PETITIONER
SAM JOHNSON
DATE: JUNE 24, 1996
PETITION NO. 96-75

PETITION NO. 96-75
REVISED DATE:
SEPTEMBER 16, 1996
AS FOR PUBLIC HEARING

METRO LINCOLN MERCURY INC.
REZONING PLAN ADDITIONAL PARKING AREAS
730 SOUTH BOULEVARD
CHARLOTTE, NORTH CAROLINA

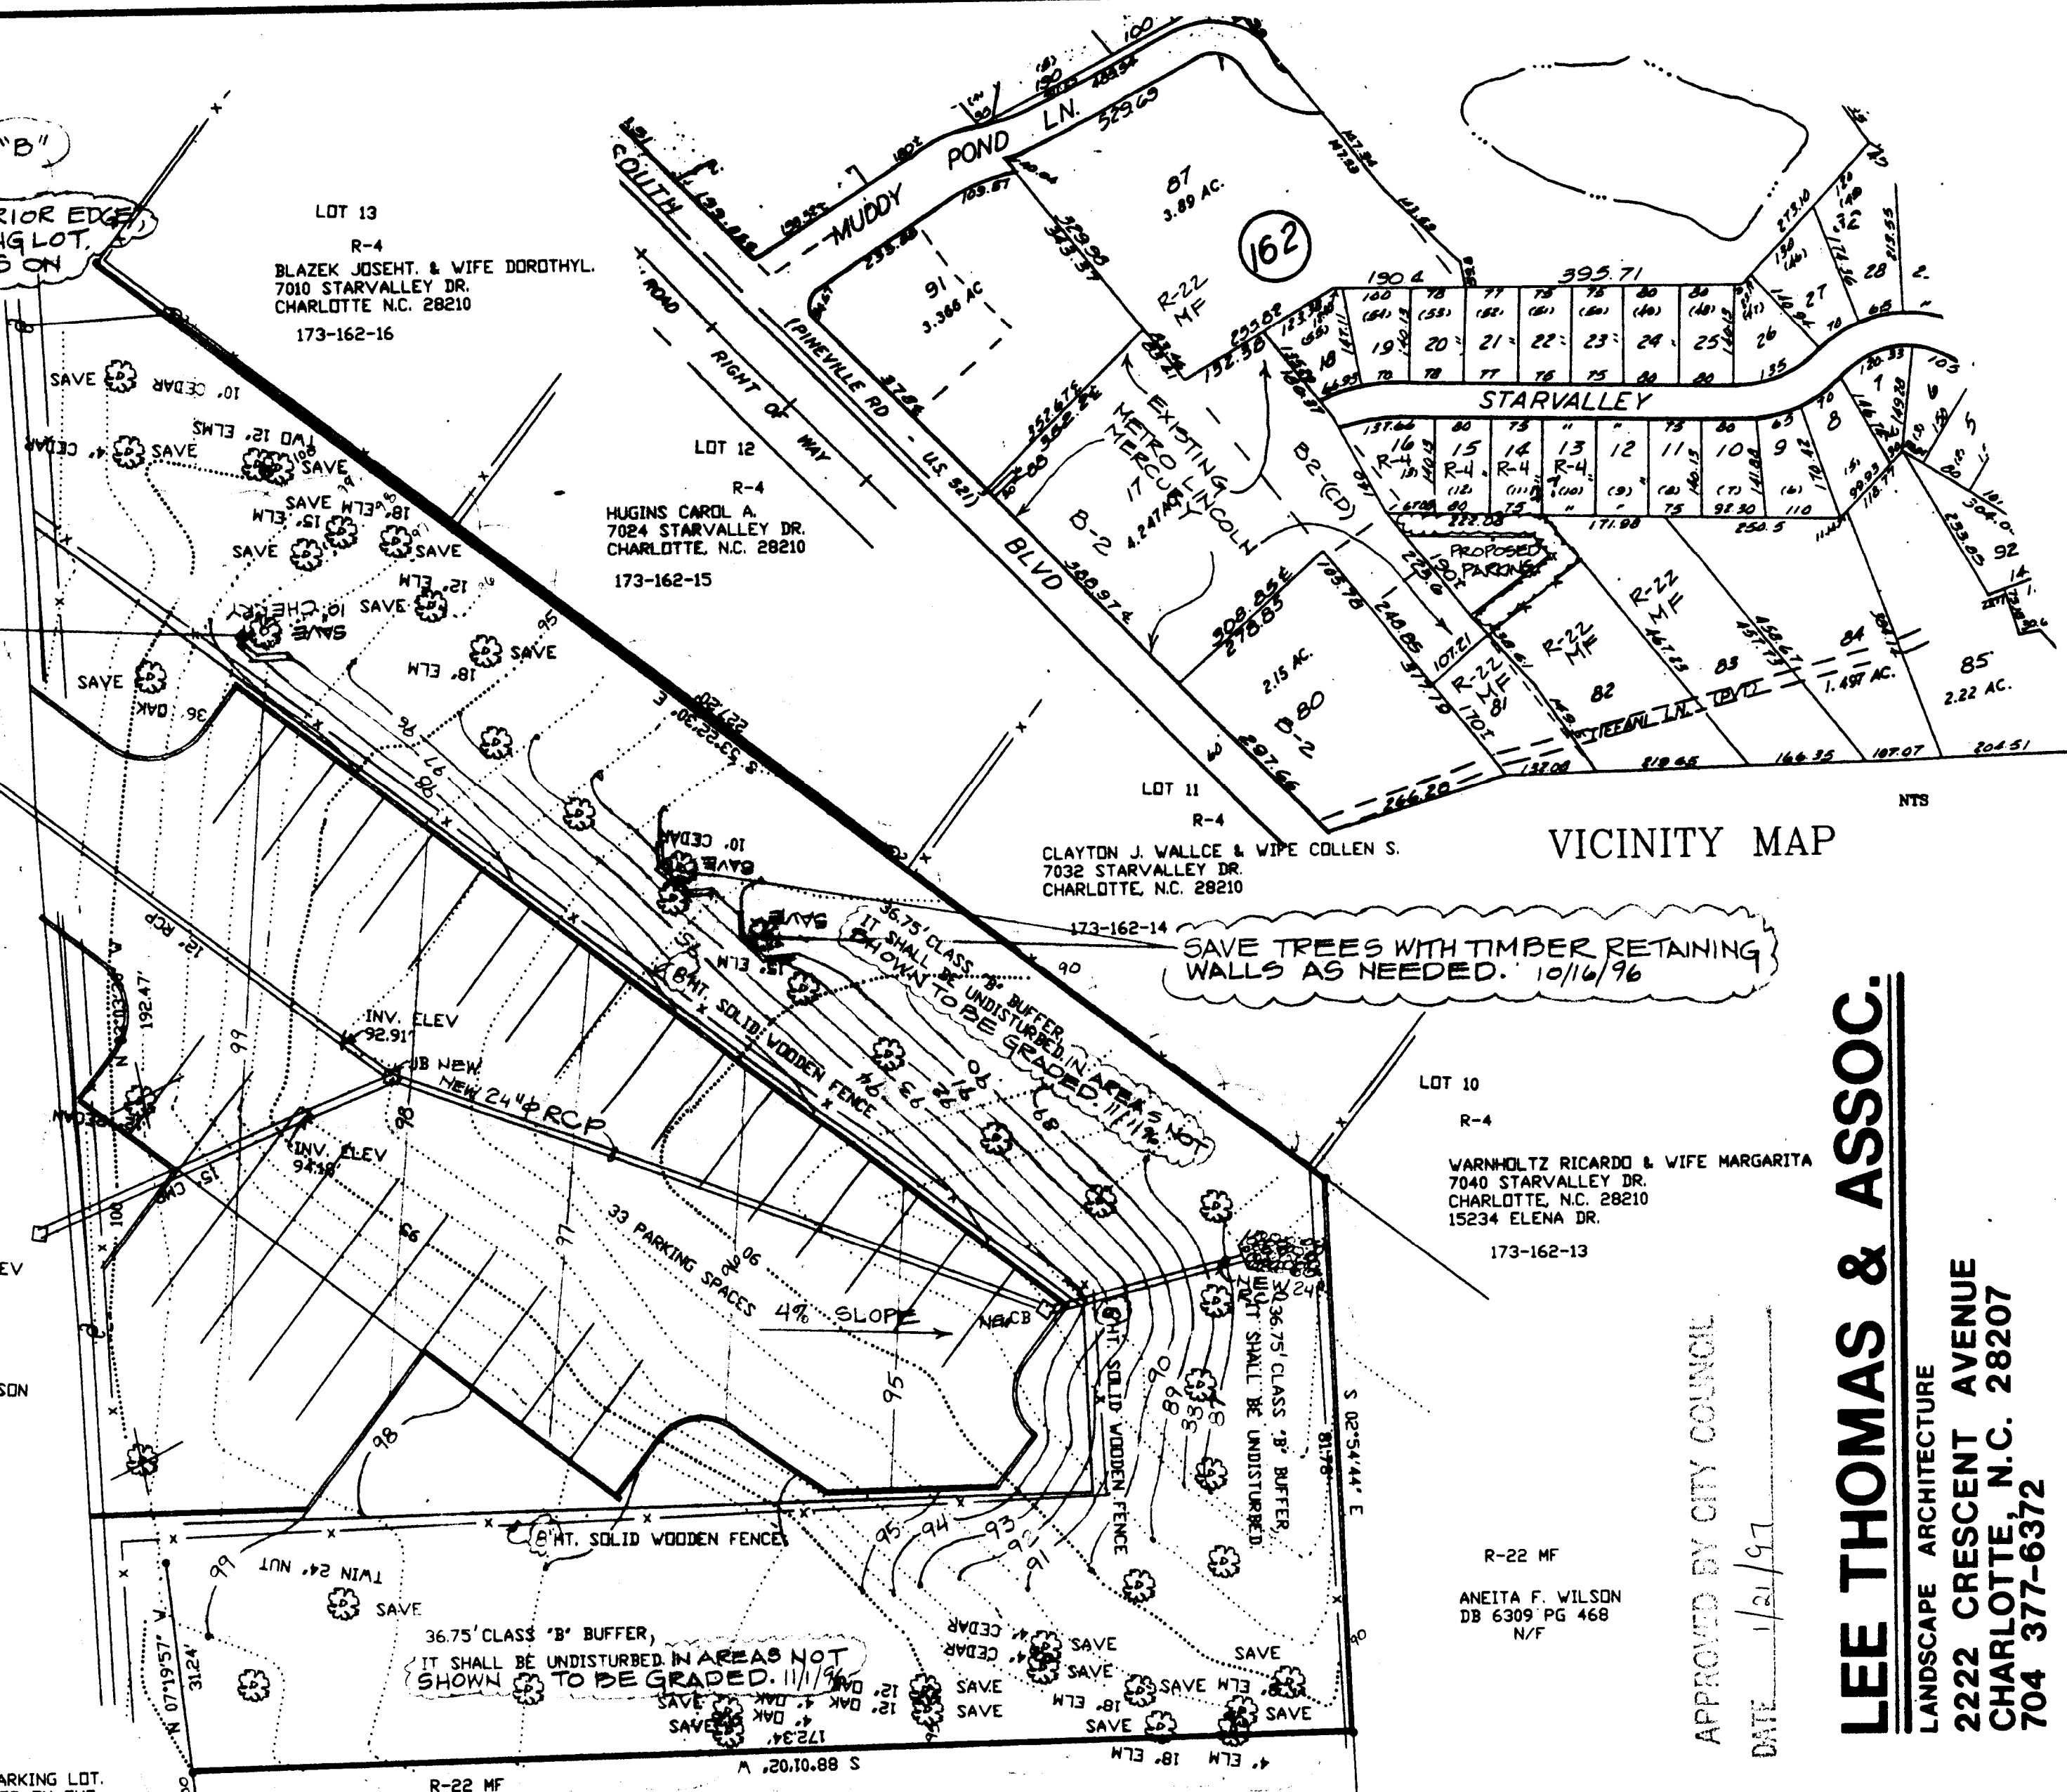
5. NEW 8' HT. SOLID WOODEN FENCE AT INTERIOR EDGE OF BUFFER, 4' BACK FROM CURB OF PARKING LOT. THERE SHALL BE NO OTHER NEW FENCES ON SITE. NOV. 14, 1996

SAVE TREE WITH TIMBER RETAINING WALL AS NEEDED. 10/16/96

SAVE TREES WITH TIMBER RETAINING WALLS AS NEEDED. 10/16/96

REVISED:
OCT. 16, 1996 PER
REACTION TO PLAN-
NING STAFF REVIEW
COMMENTS.

REVISED:
NOV. 14, 1996 PER PLAN-
NING STAFF RECOM-
MENDATIONS
